UTILITY RELOCATION PLAN

REVISED	STATE	ROUTE	STATE PROJECT	SHEET NO.
	VA.	11	0011-011-109, M-501, R-201	5(1)

PROJECT
0011-011-109

PROFILE

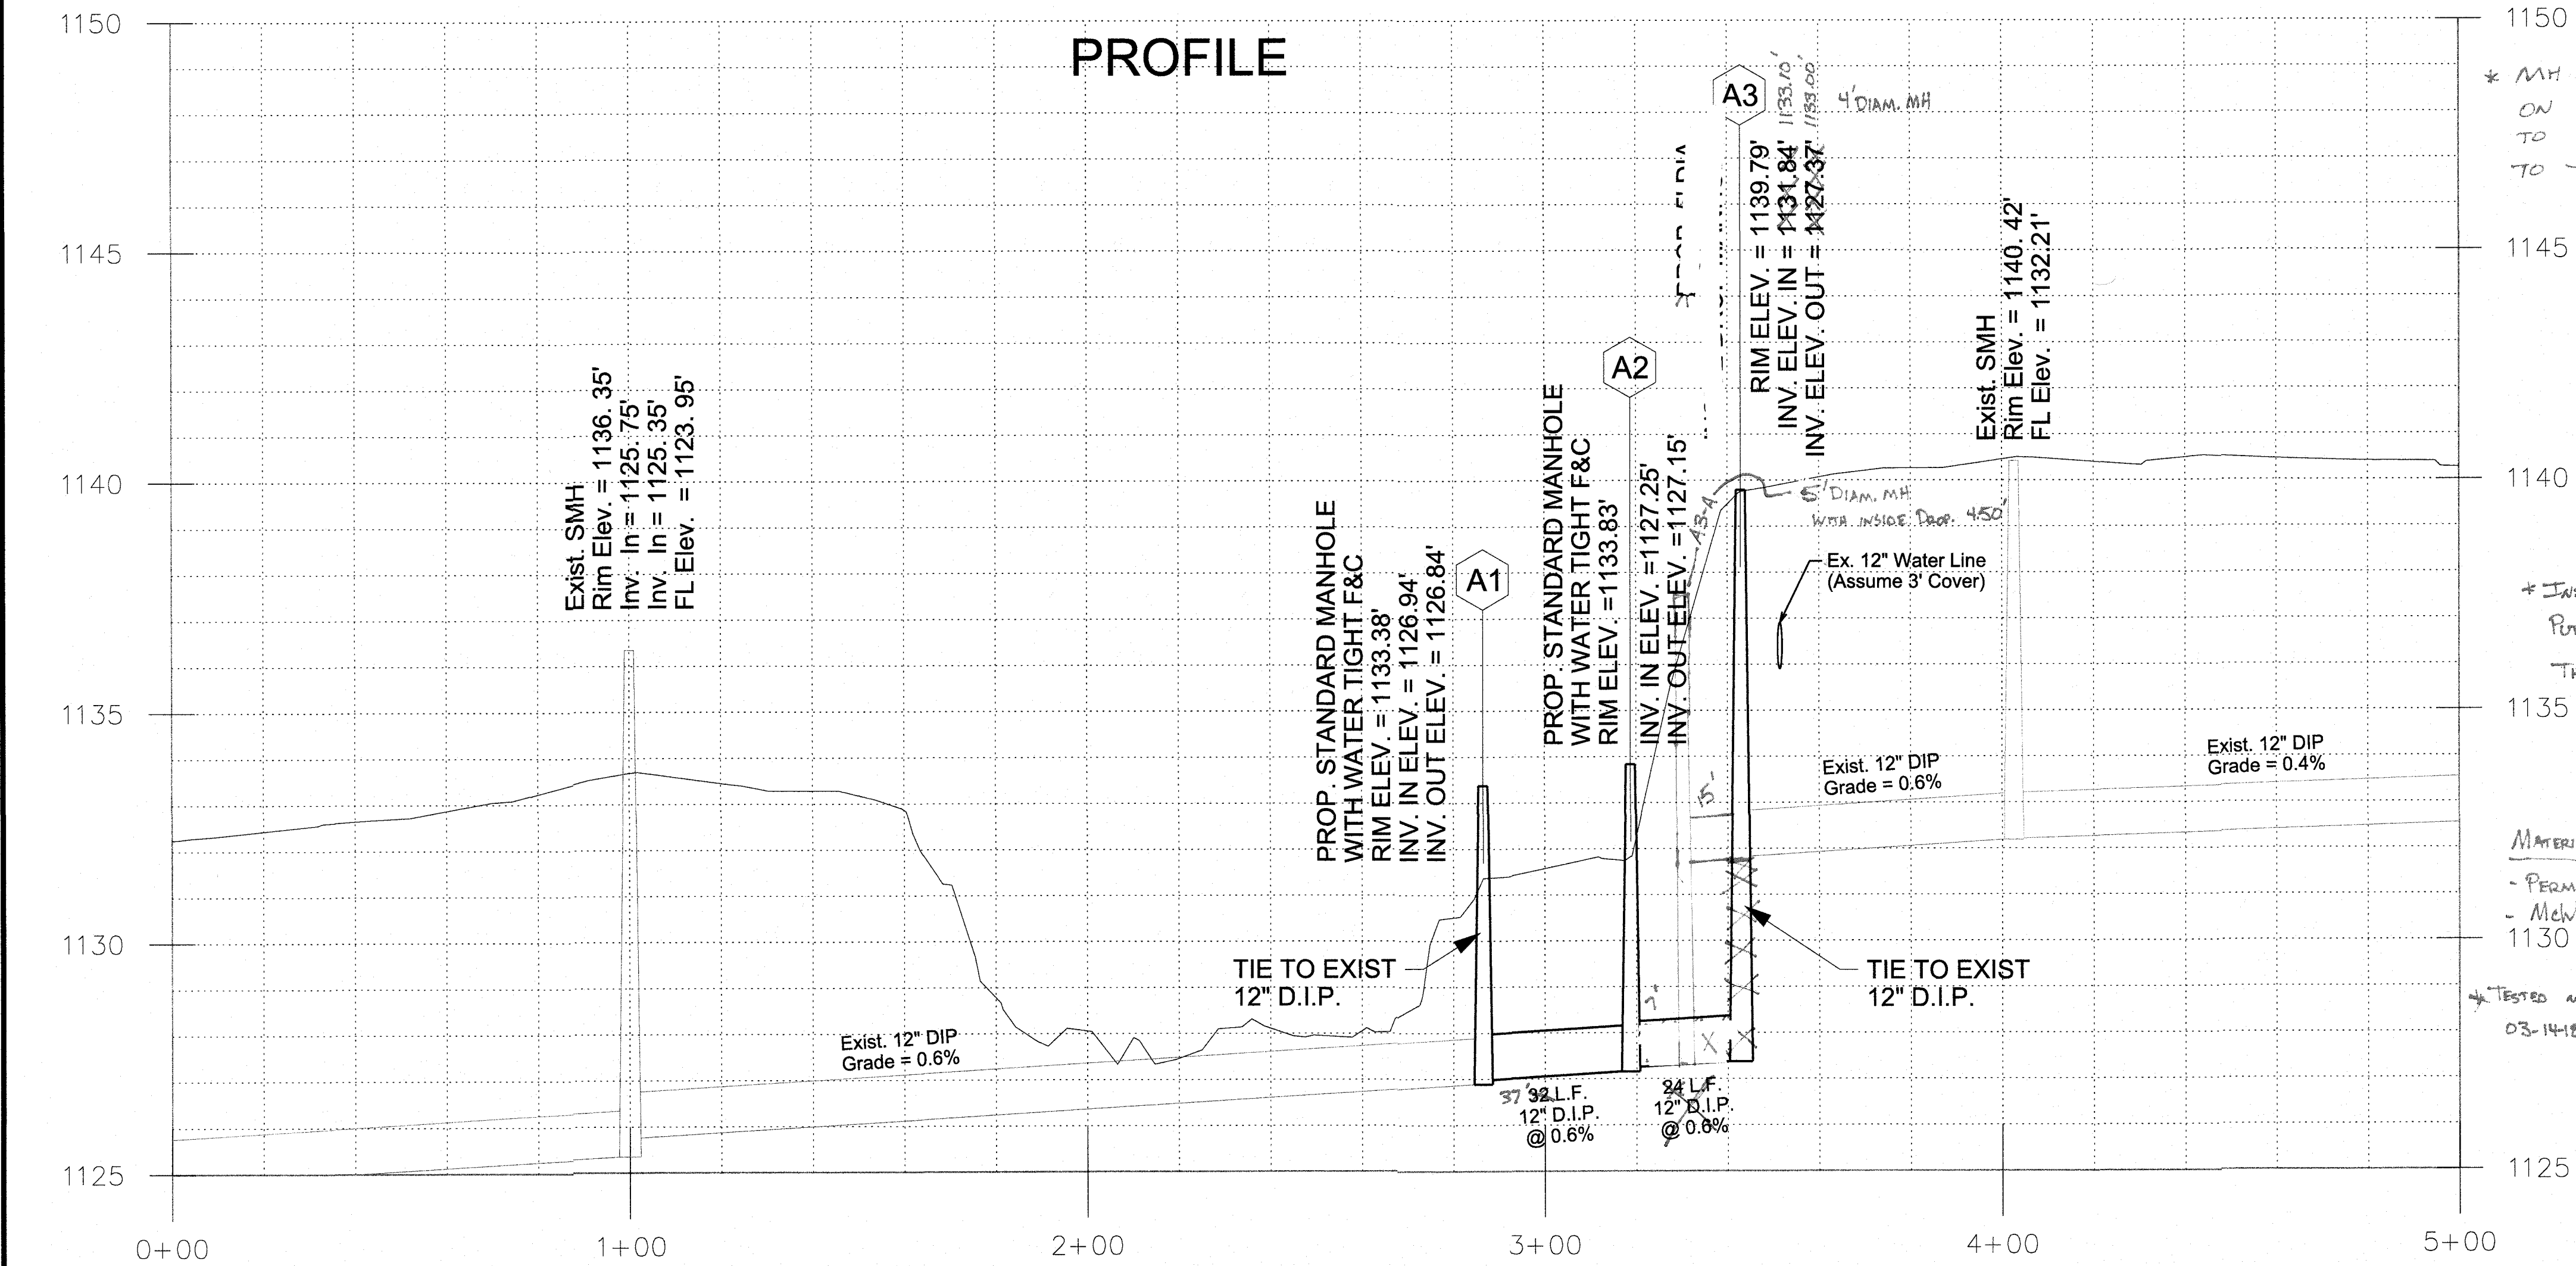
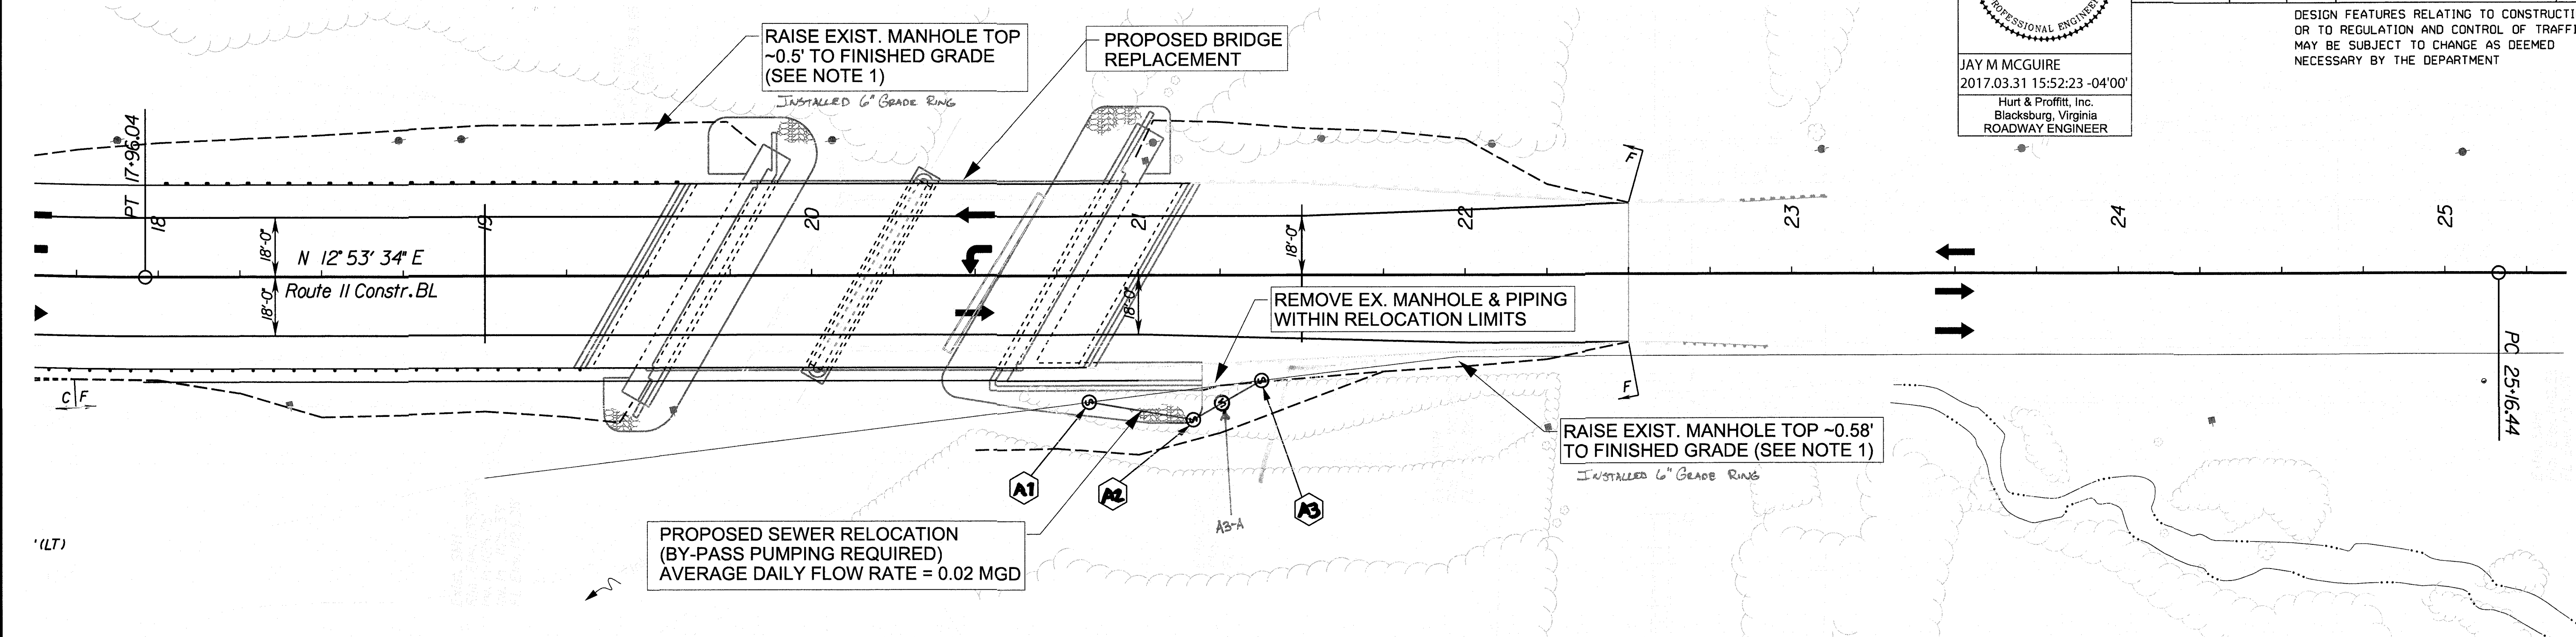
* MH A3 HAD A 2.00' RISER INSTALLED ON 08-08-18 TO RAISE THE RIM ELEVATION TO MATCH THE NEW ROAD /APPROACH TO THE BRIDGE GRADE.

* INSTALLED EXTRA SMH A3-A, 5' DIAM MH. PUT INSIDE DROP IN THIS MH INSTEAD OF A3. THERE WAS CONCERN DIGGING OUT SO DEEP AT ORIGINAL DESIGN ELEVATION ON MH A3 DUE TO ADJACENT 12" WATERLINE AND IT BLEWING OUT.

* TESTED NEW LINES AND MHS 03-14-18.
